Agenda – Board of Adjustment – January 8, 2020

Item No. 2 Variance – 235 Andrews Street
(Mynarski Ward)
File DAV 213642/2019C [c/r DCU 213647/2019C]

ADMINISTRATIVE REPORT

Title: DAV 19-213642\C – 235 Andrews Street

Figure 3: Site plan submitted with application.

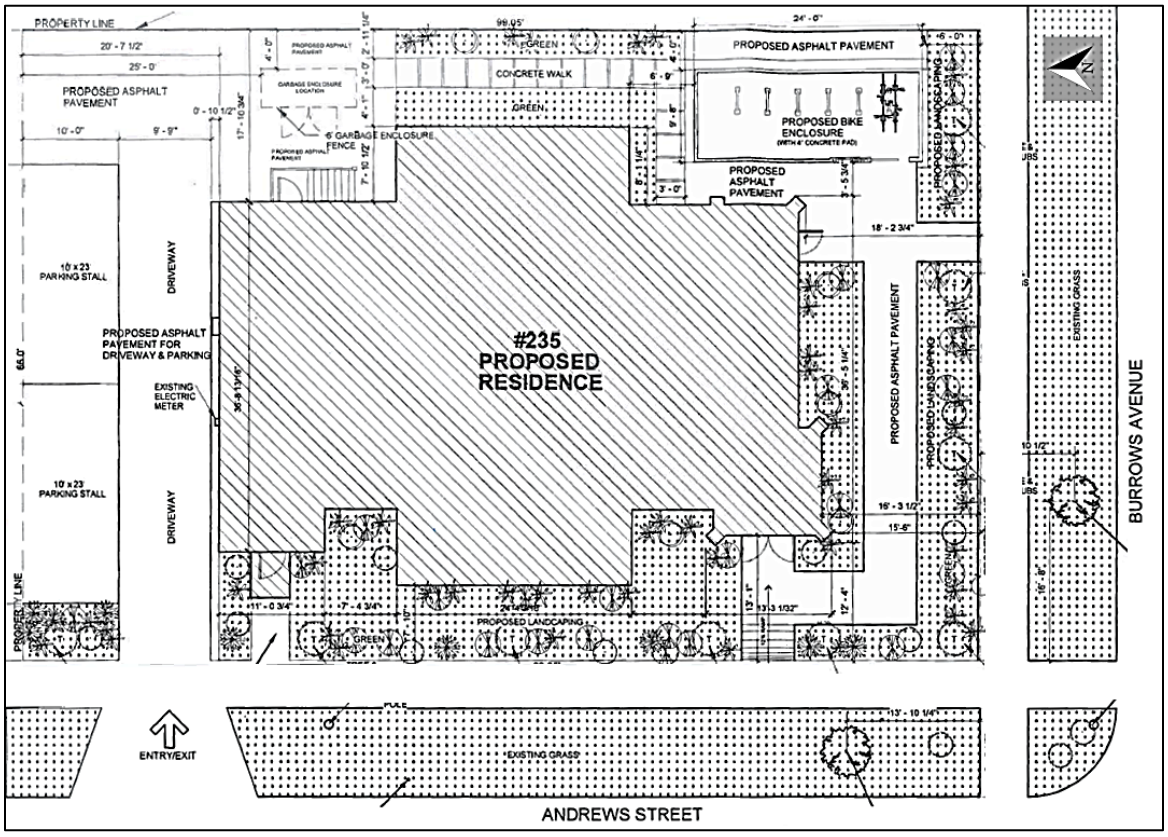
Initially, the applicant proposed a wider drive aisle with narrower parking spaces. The Public Service suggested the applicant modify the parking layout such that parking spaces are wider

(in order to be functional given they would be located next to a fence) and reduce the width of the drive aisle accordingly.

Figure 4: Proposed bike enclosure, 3D view.

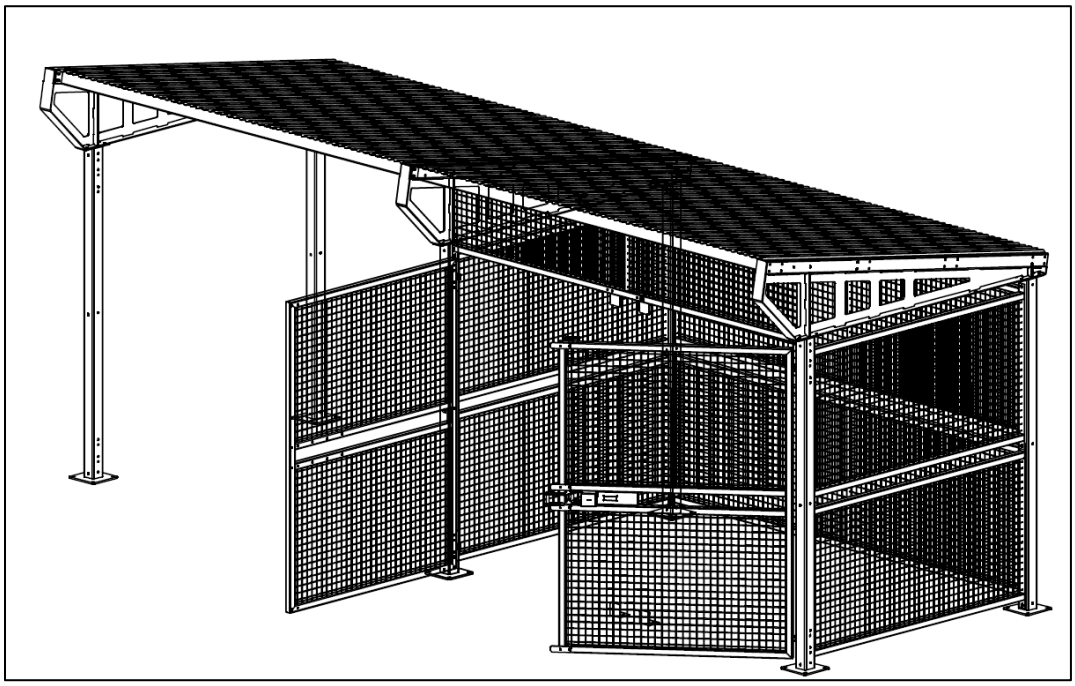
With respect to the variance to allow a reduced front yard for the bike enclosure, as noted, the site is constrained. There are no other locations to place the enclosure without either reducing its size (thereby reducing the amount of bicycles it could accommodate) or significantly altering the building (which is also not desirable).

It is worth noting that most of the enclosure would be located in the side yard and thus comply with the bylaw. The structure would be 7.5 ft. wide by 24 ft. deep. Only 8 ft. of the structure would be in the front yard. Reducing the depth of the enclosure would reduce the amount of bike parking it can accommodate.

The structure would also be set back 4 ft. from the east property limit, which abuts a single-family residence. The property immediately to the east contains a set of concrete stairs and the proposed enclosure would line-up with those stairs.
